PETITION FOR REVIEW
OF REFUSAL TO ENFORCE
CALIFORNIA WATER CODE
AND UNITED STATES CLEAN
WATER ACT
(Water Code §13320)

POINTS AND AUTHORITIES FOR
PETITION FOR REVIEW
OF REFUSAL TO ENFORCE
CALIFORNIA WATER CODE
AND UNITED STATES CLEAN
WATER ACT

Amador Canal and Jackson Creek Flows for Year 2003

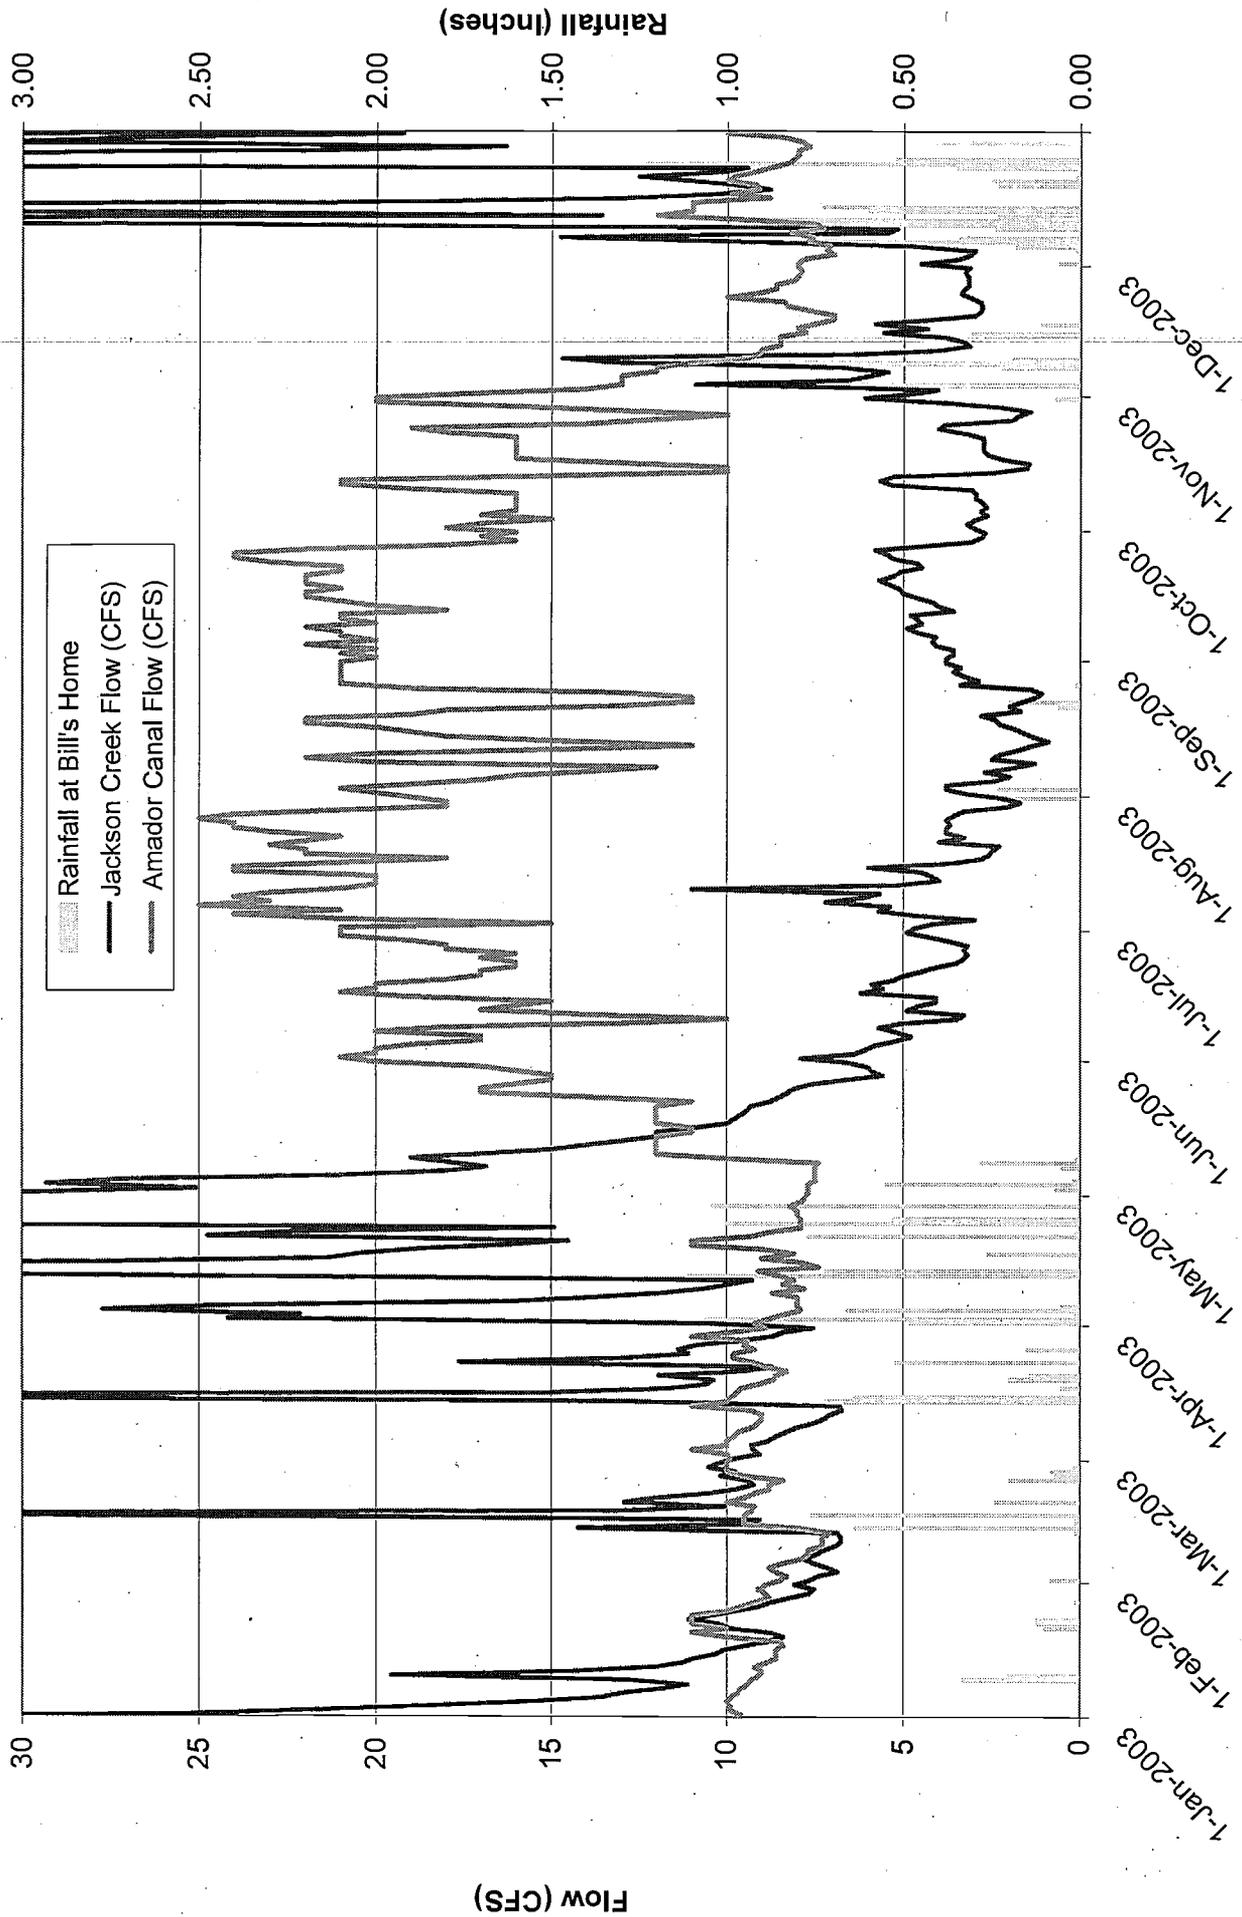
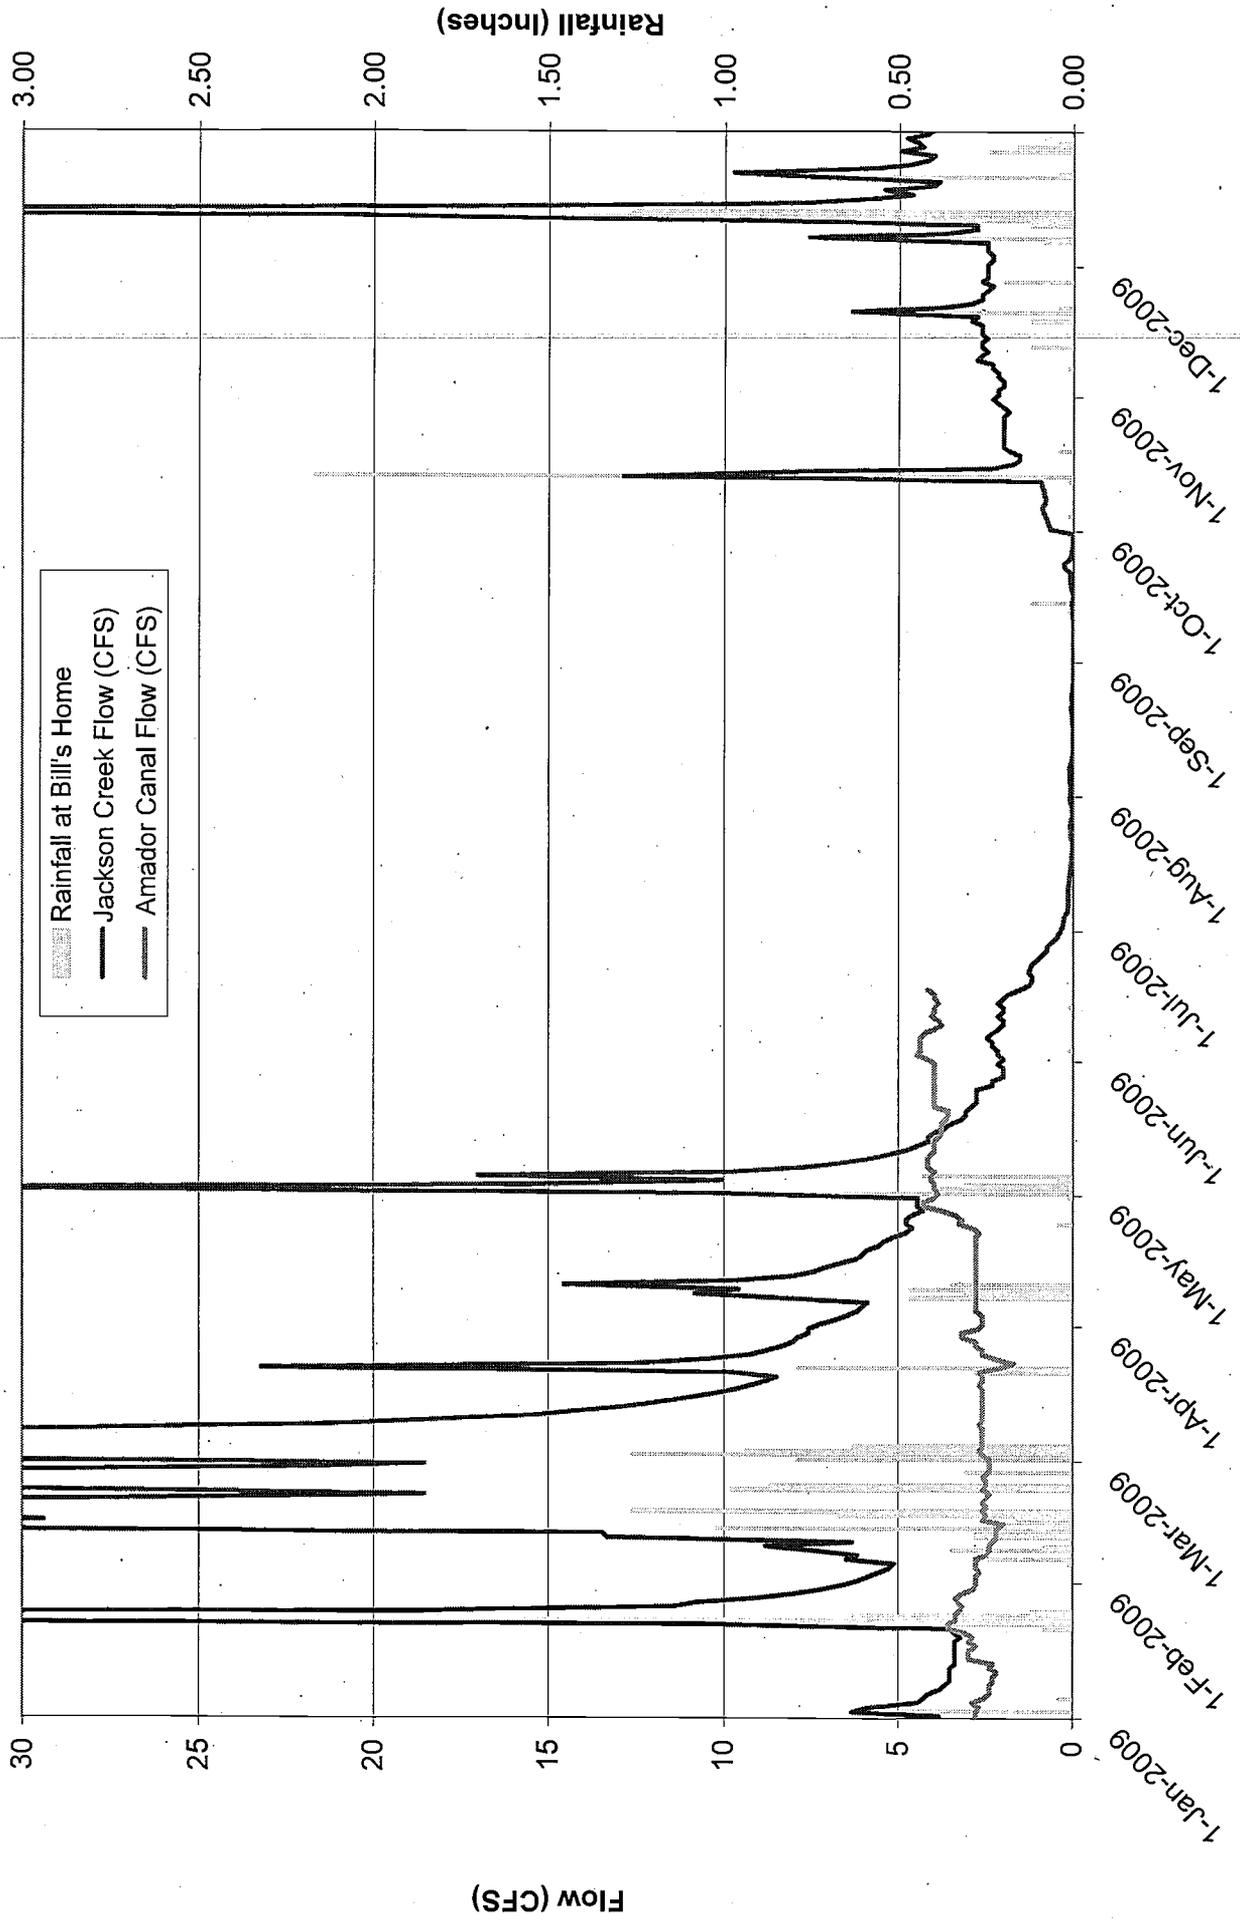
The charts for years 2003⁶ and 2009⁷ show that Ecologic/Stantec never made the analysis claimed in the BUAS. The rainfall was 26.89" in 2003 and 27.84" in 2009. Yet the creek became intermittent in 2009 and not in 2003. The difference, of course, is that the Amador Canal was in full operation, and leaking, in 2003 and flowed far less volume in 2009. The canal has not been fully closed, so the stream conditions will be even worse in the future. The hydrological model used by Ecologic/Stantec, that Jackson Creek flows are determined by regional climate cannot explain the actual data because the model is invalid.

Amador Canal and Jackson Creek Flows for Year 2007

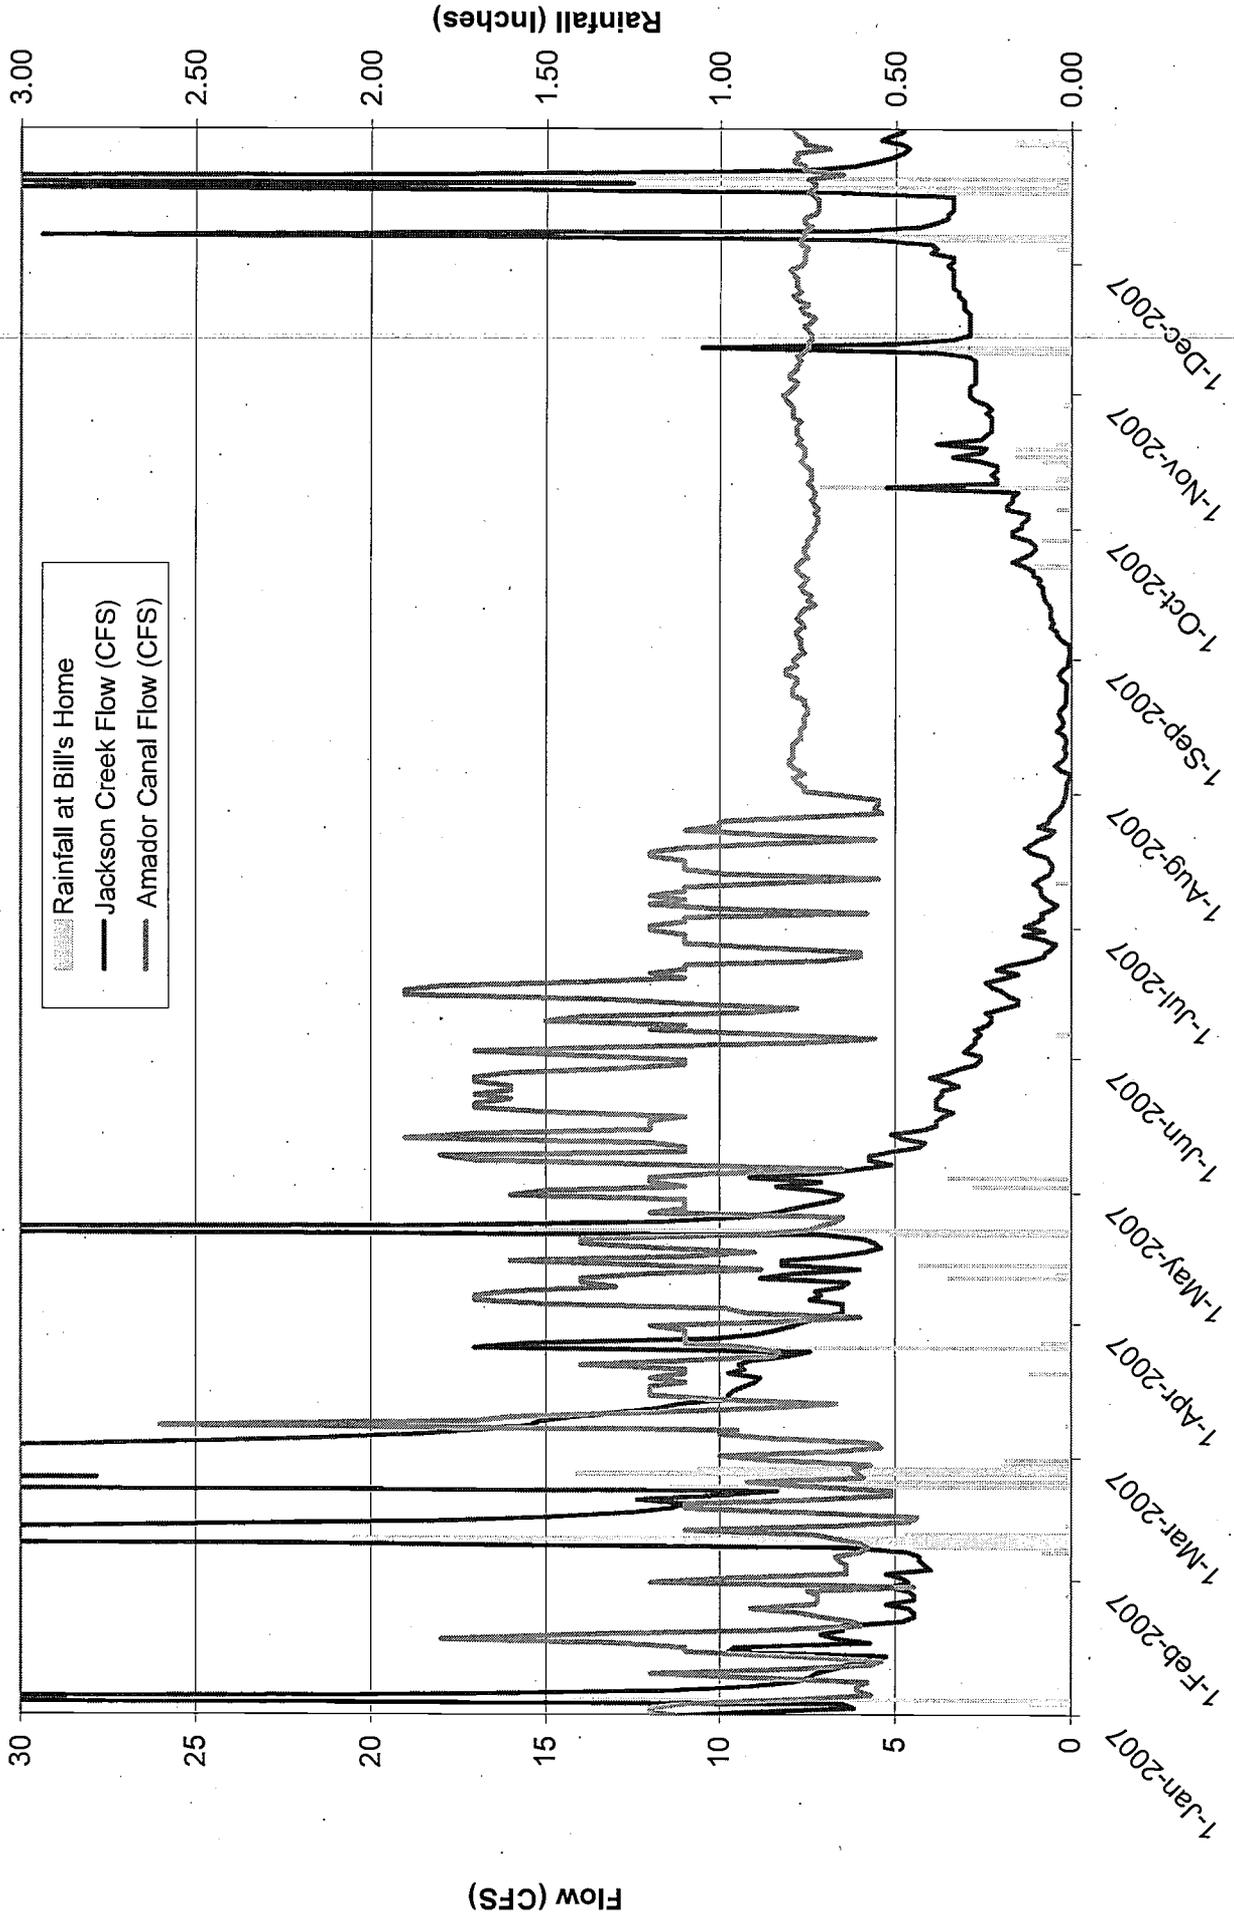
1 25. Page [000023] shows the actual flow data for 2007. The Creek became dry for several
2 days. Therefore the correct conclusion based on the data available at the time the BUAS was
3 prepared is that the Creek becomes dry in 2 of 8 (or 1 in 4) years.

Amador Canal and Jackson Creek Flows for Year 2009

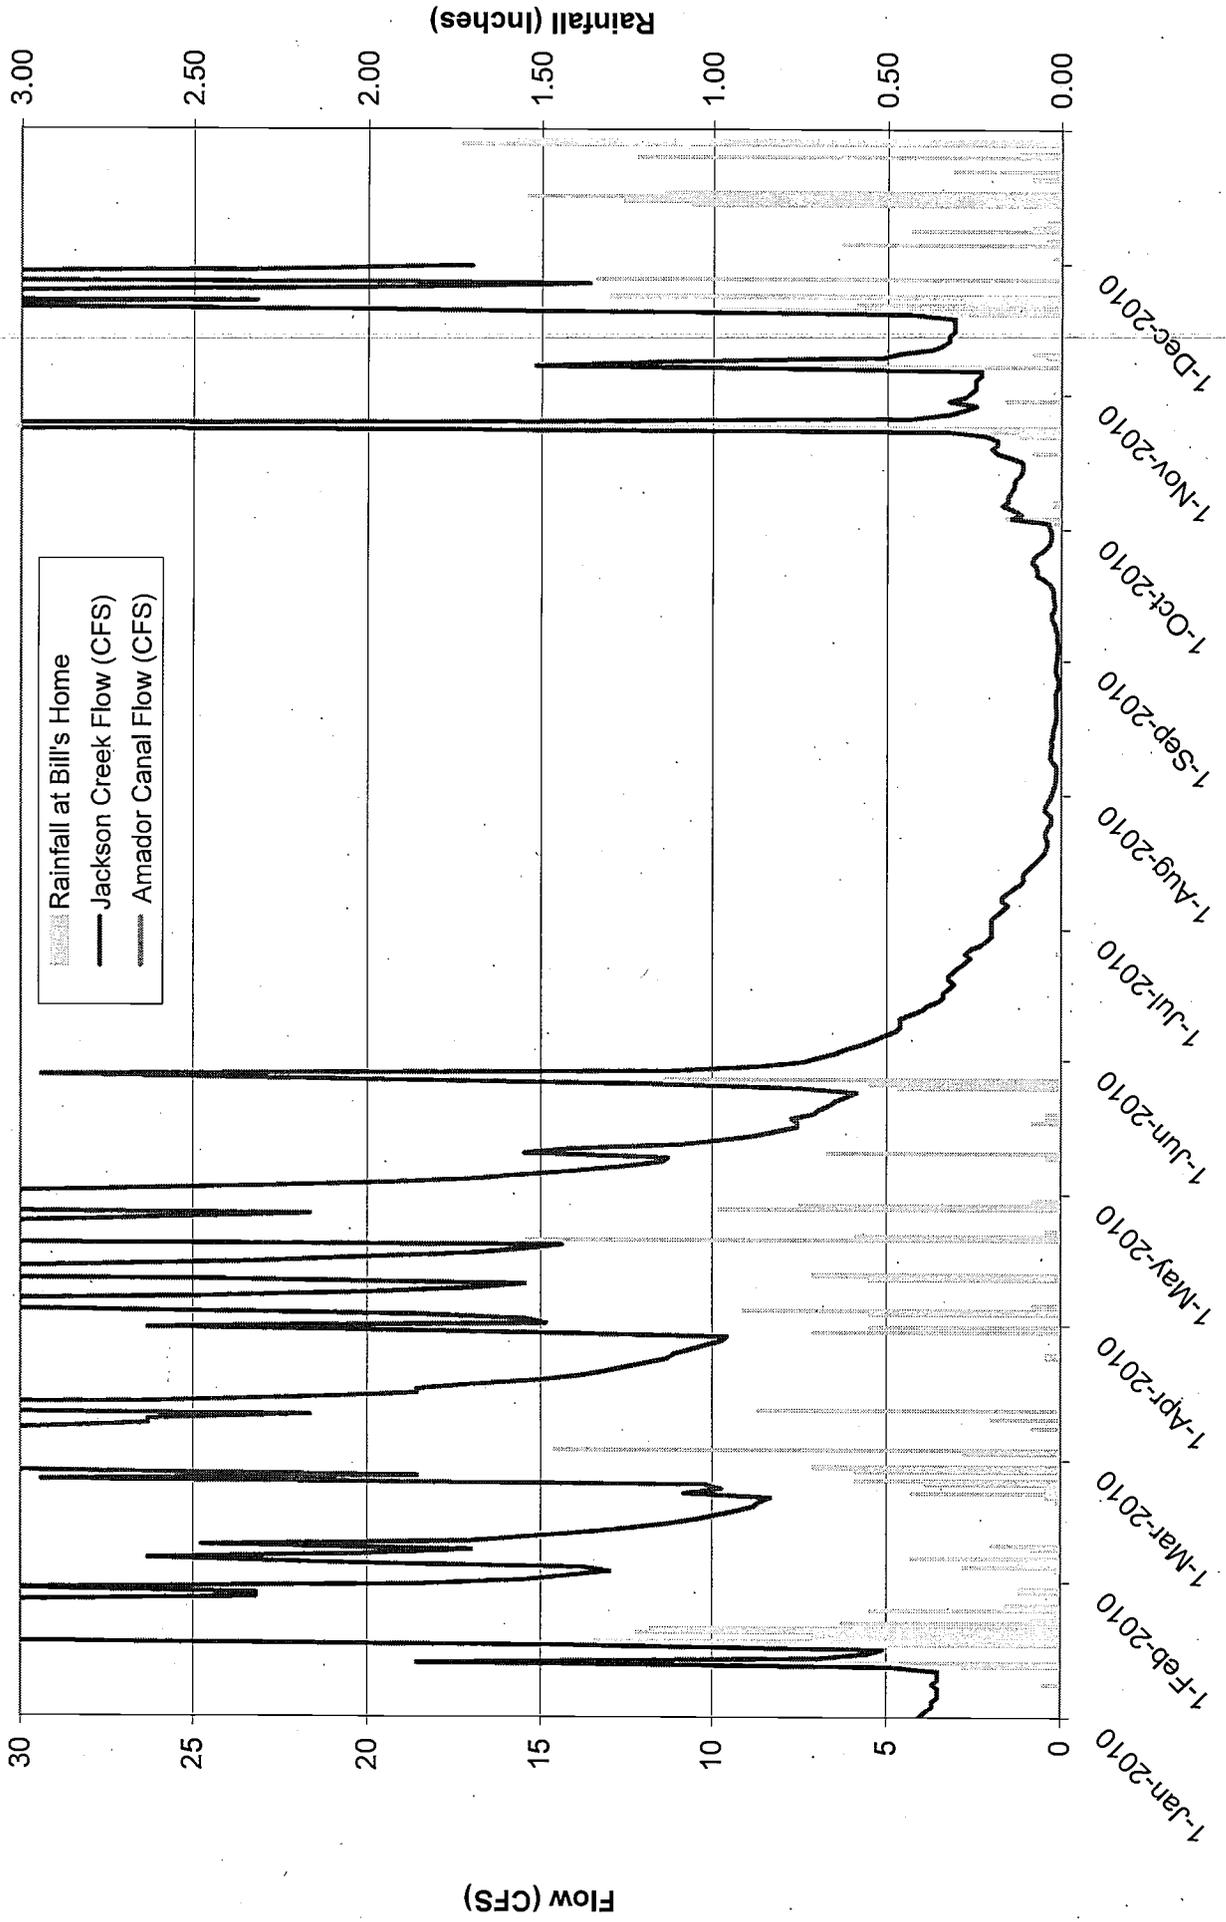
4 26. Pages [000025-000026] show the actual flow data for 2009 and 2010, which were not
5 available at the time the BUAS was prepared. They confirm that Jackson Creek becomes intermittent
6 every year.

Figure ES-1
Project Study Area

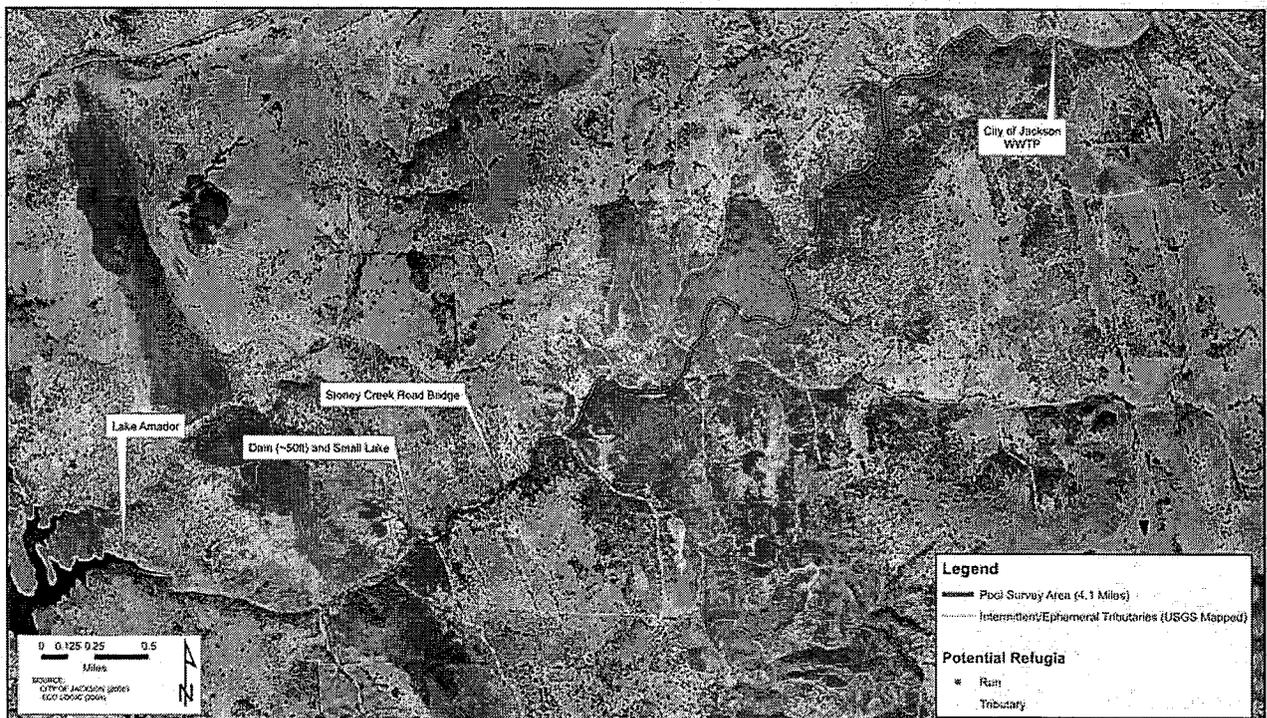
The scope of the BUAS is inadequate. Page ES-1¹⁰ in section ES.1 (Historical Perspective and Existing Conditions) indicates that the pool survey area extended 4.1 miles downstream of the WWTF. That is not all the way to Lake Amador and the entire stretch of Jackson Creek between the WWTF and Lake will be affected. Furthermore, the gradient of the creek suddenly steepens immediately downstream of the "Dam (50 ft) and Small Lake", as shown in Figure ES-1 on page ES-1. That is because a different geologic formation is entered.
